SITE ADDRESSES: 1330 and 1410 South Bascom Avenue (APNs: 282-26-011, 282-26-012, and 282-26-007)

RE: File No. PD18-015: Planned Development Permit to allow the demolition of an approximately 76,894 square feet of existing commercial buildings, and the construction of an approximately 213,500-square foot office building, 590 residential units, an alternative parking arrangement (tandem parking), and the removal of **two** ordinance and ___ non-ordinance sized trees in the CP(PD) Planned Development Zoning District on a 6.98-gross acre site, commonly known as Dick's Center.

**SUBJECT: REVISED INITIAL RESPONSE TO
DEVELOPMENT APPLICATION**

Figure 5.3: Transitional Height Diagram applies to properties inside and outside the Urban Village boundary with a Mixed-Use Neighborhood General Plan designation

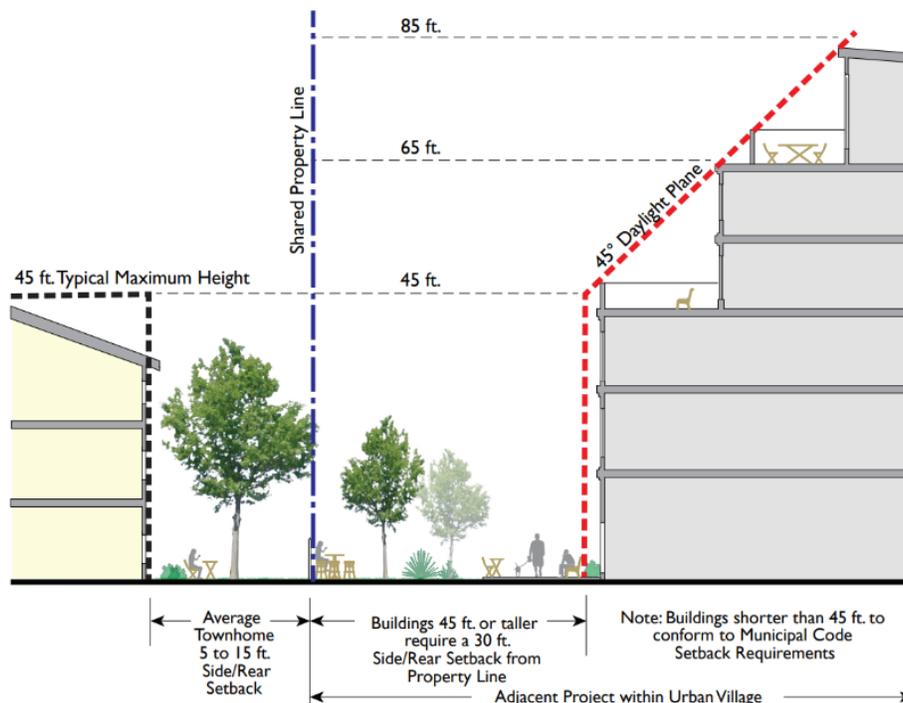
The residential building provides a setback from the adjacent residences in conformance with the development standards and the Urban Village Plan as shown in the diagram to the right and encouraged by the Residential Design Guidelines (SBUV Goal UD-4; SBUV Policy UD-4.1; SBUV Policy UD-4.2; SBUV Policy UD-4.4; RDG pg. 138). Furthermore, the massing and orientation of the residential building increases the compatibility by placing the majority of the massing along the plaza and South Bascom Avenue (RDG pg. 137). This transition allows for light and air to easily access the adjacent residential units, particularly since the southern façades are facing this project. This level of sensitivity to the existing context is further increased with the large setback doubling as an emergency access route and loading/services access road.

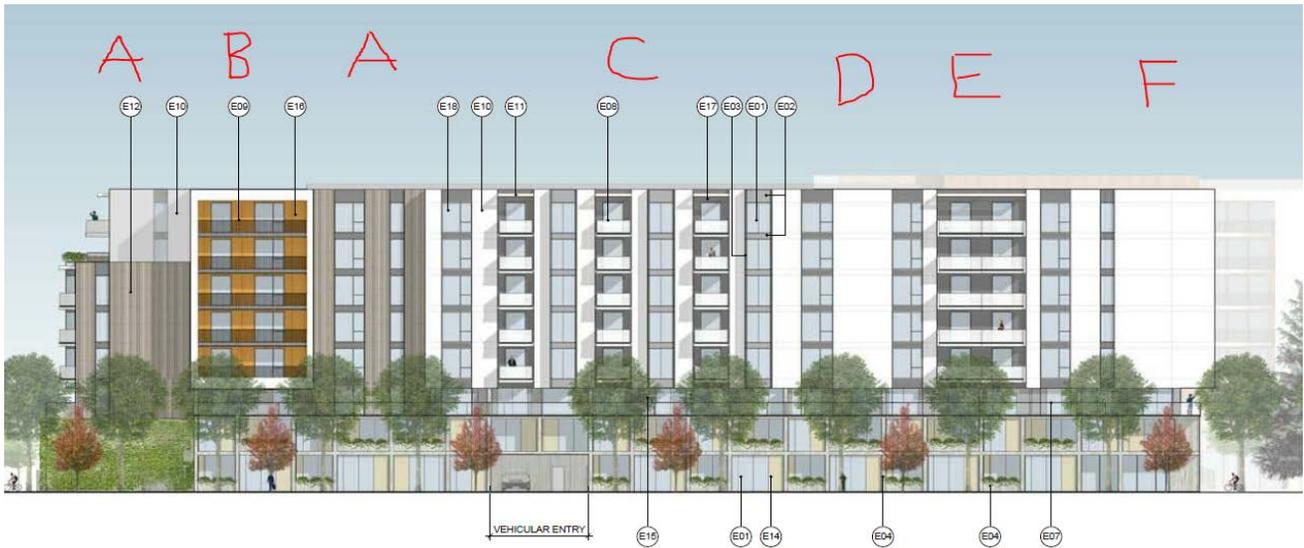
The plaza provides a direct line of access with clear sight lines from South Bascom Avenue and the Bascom Light Rail Station (SBUV Goal LU-3; SBUV Policy LU-3.2; SBUV Policy P-1.3; SBUV Policy UD-3.2; SBUV Goal CS-2; SBUV Policy CS-2.1; SBUV Policy CS-2.2). This permeability will be increased and supported by a thoughtful layout of programmed spaces including, but not limited to: tot lot, benches and tables, water feature, and public art (SBUV Policy P-3.3). In order to understand the plaza design better, **please provide three section cuts with the next submittal.**

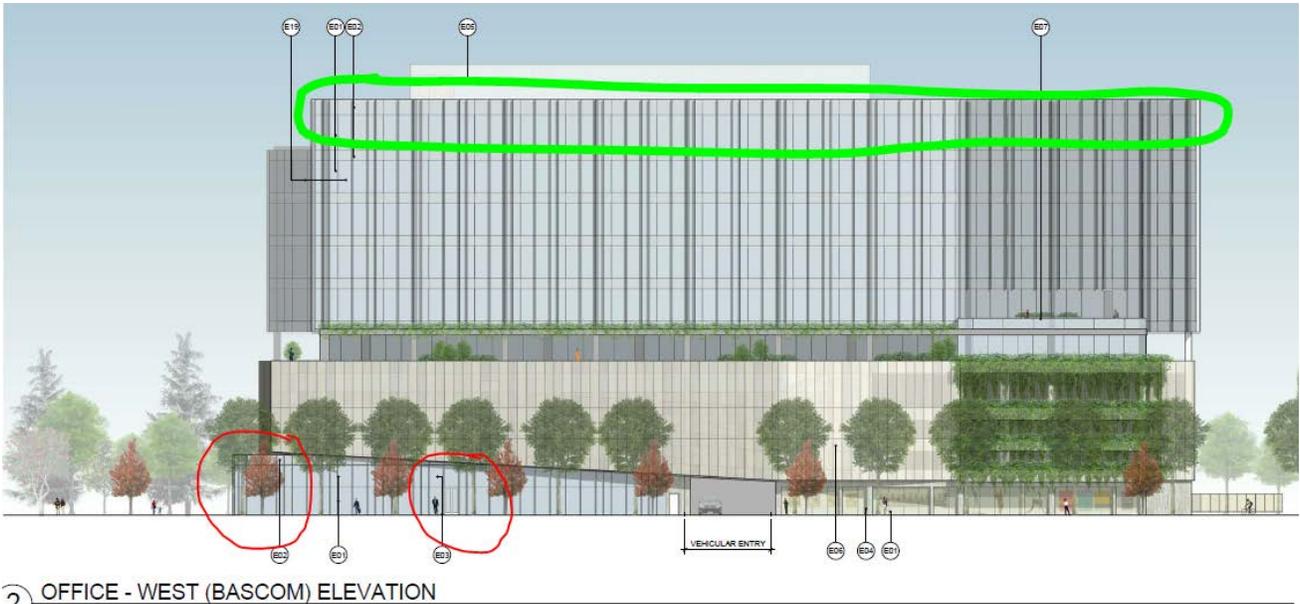
A gateway element on the southern façade (Sheet A-7b.1.1) is missing. The Village Plan calls for the strategic location of iconic building elements, plazas, art, and open spaces within new developments to announce and celebrate gateway nodes (SBUV DG Ground Floor Articulation #4 pg. 62). While an attempt at the corner of South Bascom Avenue and Southwest Expressway was made to define the gateway with a landscaped area, further definition of the building itself is required. This is particularly critical at this location given the need for locating loading and service entrances at this corner. To address this, explore the placement of an art piece or other defining feature in the southernmost landscaped area to provide a defined gateway. Worth exploring is the reuse of the existing Dick's Center sign pursuant to [San Jose Municipal Code Section \(SJMC\) 23.02.1200 for legal nonconforming signs](#). After relocation, message on the sign can be altered to reflect the tenant of the office building or reflect the name of the development (more on signage below). If signage is not explored, use of artwork and better building façade articulation is an option to reduce the blank, unarticulated walls on this façade (SBUV DG Ground Floor Articulation #7 pg. 62).

VIEW FROM VTA LOOKING WEST INTO PARK/PLAZA

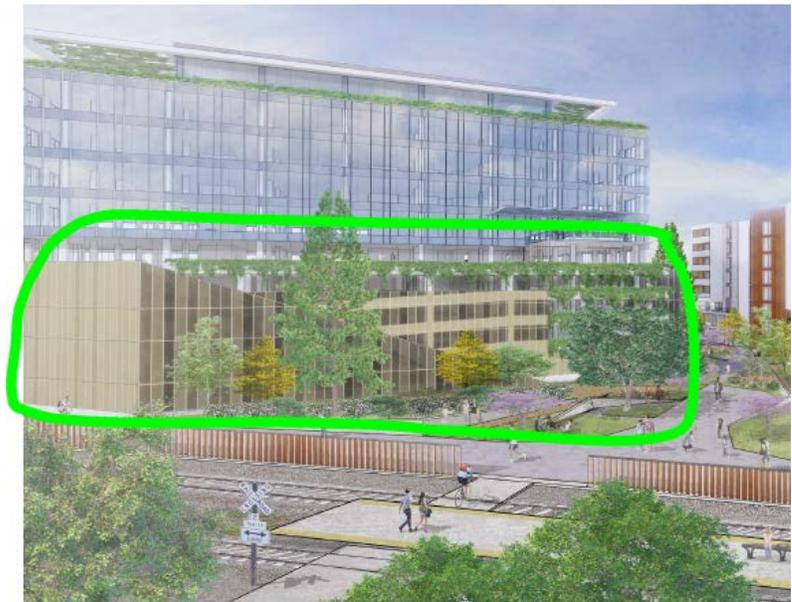
The rear of the office building facing the plaza has a staircase element (circled in green). It appears to provide access to the roof of the fourth floor with open space amenity space for the office user. **Please clarify how this will operate (i.e., will it be open to the public?).**

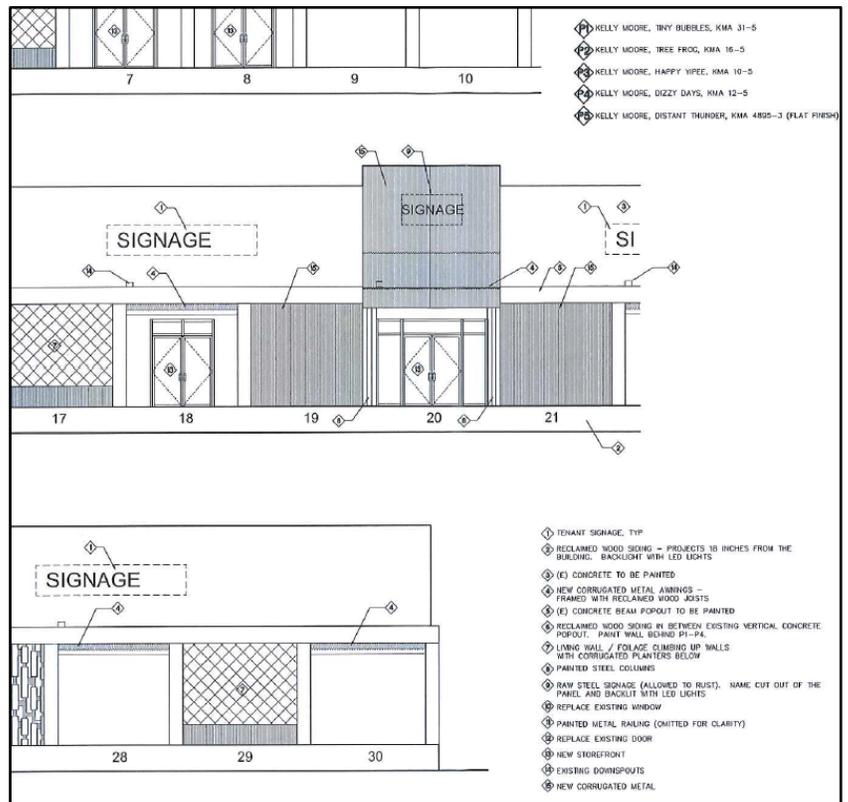
- j. Provide a narrative (on the plan set) indicating if any parking reductions are being utilized, such as the 20% parking reduction allowed by-right to projects within an Urban Village. This could also be a 50% parking reduction with a Transportation Demand Management (TDM) program if desired. The project appears to be asking for a more than a 20% reduction in parking for the office use, which requires the issuance of a TDM program. The residential use appears to provide more than the Code required parking spaces which is not allowed. **Please explain with the table requested and a narrative (if unclear) explaining the rational for the parking numbers.**

19. Sheets L-11.1 and L-11.2: Lighting Plans

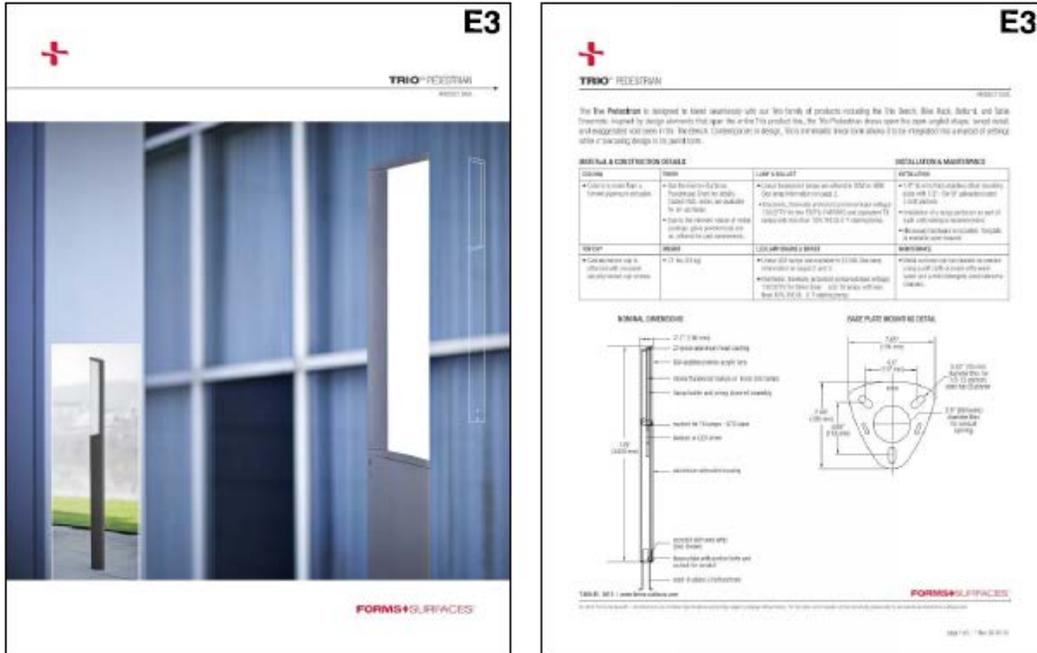
- a. This project is subject to the City’s [Outdoor Lighting Policy on Private Developments](#). The purpose of this policy is to promote energy efficient outdoor lighting that provides adequate lights for night time activity without impacting nearby properties. Lights must be fully shielded (light bulb parallel to the ground), which means this light is likely not allowed. **Provide more information about which way the light is directed to determine if the light is allowed.**

- b. Light also cannot spill onto adjacent properties. Please be mindful of this.
